**RE: Supplemental Geotechnical Review - Revision 2  
Proposed Armstrong Estates Residential Subdivision  
Mansfield, Ontario  
Project No. 2204585**

**DRAFT PLAN OF SUBDIVISION  
 ARMSTRONG ESTATES  
 OF MANSFIELD**

**EROSION HAZARD LIMIT**

Fig. 1

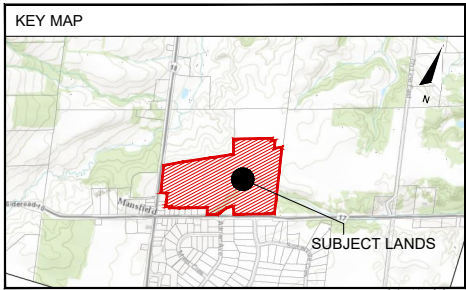
- ***Comment 4:*** *Please provide an existing conditions erosion hazard limit drawing that is signed and sealed by the qualified professional. Please include with a legend that clearly identifies the separate components of the slope erosion hazard limit assessment, including a clearly defined long-term stable top of slope limit line from the assessment, plus a separate 6 m access allowance limit line. This separate information is not clear in several*

locations on the proposed conditions Draft Plan, considering the text provided with the line types.

**GEI Response to Comment 4:** A PDF of the requested drawing is attached as Figure 1. It is noted that the “Top of Bank” coincides/exceeds the Erosion Access + Stable Slope Allowance component for all slopes on both sides of the creek, shown on the drawing.
